Re: CBE Comments on Phillips 66 Rodeo Refinery Propane Recovery Project Draft Environmental Impact Report (**State Clearinghouse #2012072046, County File #LP12-2073**)

Phillips 66 map indicating plans to transport Western Canadian crude oil to the Rodeo Refinery.

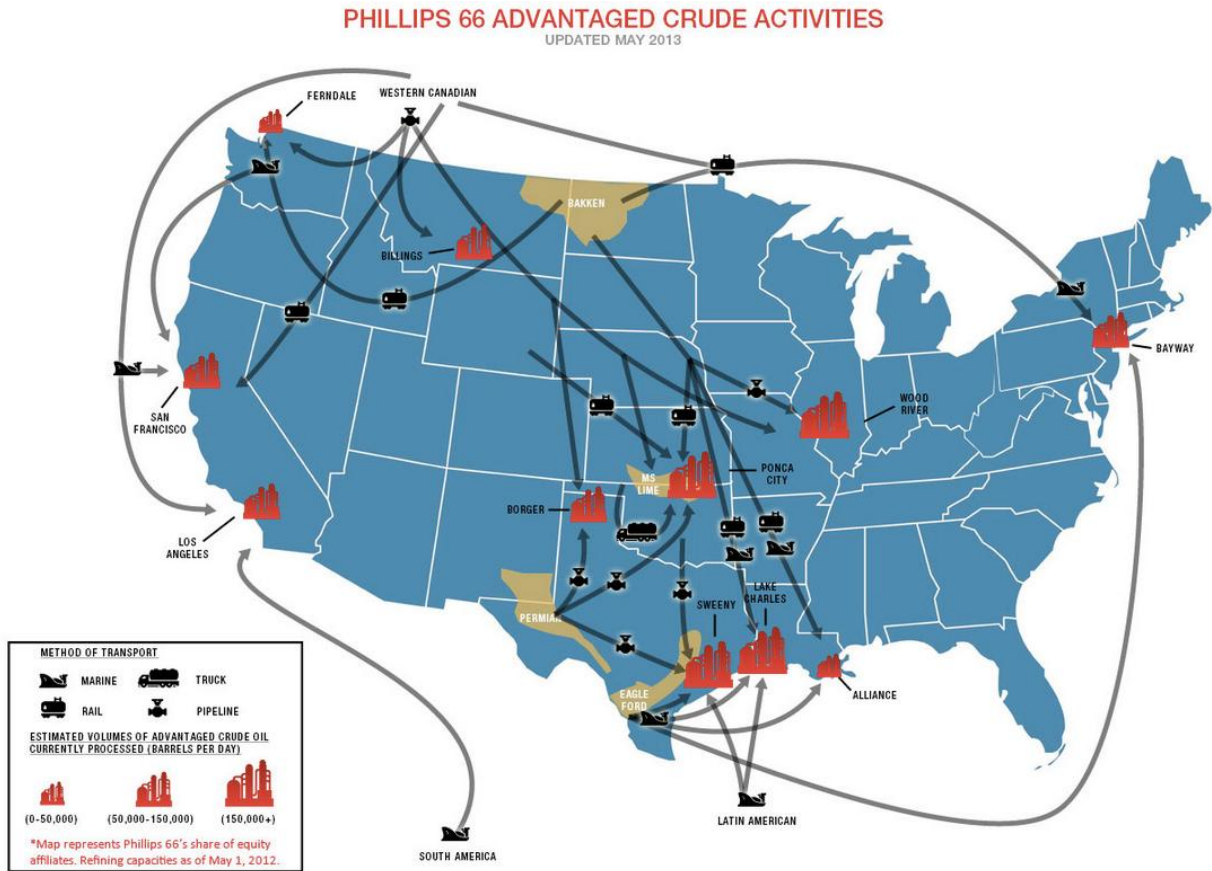
The omission of adequate information is particularly perplexing where the missing information is publically available. Readers of any EIR should not be forced to sift through obscure minutiae or appendices, or to rely on outside research and resources to find important components of a thorough environmental analysis. *San Joaquin Raptor Rescue Ctr. v. County of Merced* (2007) 149 Cal.App.4th 645, 649; *see also, California Oak Found. v. City of Santa Clarita* (2005) 133 Cal.App.4th 1219, 1239. Here, the DEIR does not disclose pertinent information relating to the anticipated source and quality of crude feedstock the Refinery plans to process. Yet Phillips 66's has announced to the public its strategy of shifting to refining "advantaged crude." Phillips 66 defines "advantaged crude" as "heavy crude oil from Canada and Latin America, lighter Canadian grades, and West Texas Intermediate (WTI)." *Phillips 66 Delivers on Advantaged Crude Strategy*.² A map available on the Phillips 66 website (shown below) specifically highlights the strategy of transporting Western Canadian crude oil to the Rodeo Refinery both by marine vessel and rail. *Phillips 66 Advantaged Crude Activities: Updated May 2013*.³ Of the advantaged crude sources shown on the map, only Western Canadian crude is shown as being transported to the Rodeo Refinery. *Id.* Moreover, Phillips 66's CEO has articulated a target of shifting to 100% advantaged crude in two years. *Transcript of May 1, 2013 Phillips 66 First-Quarter Earning Conference Call*, pp. 19-20.
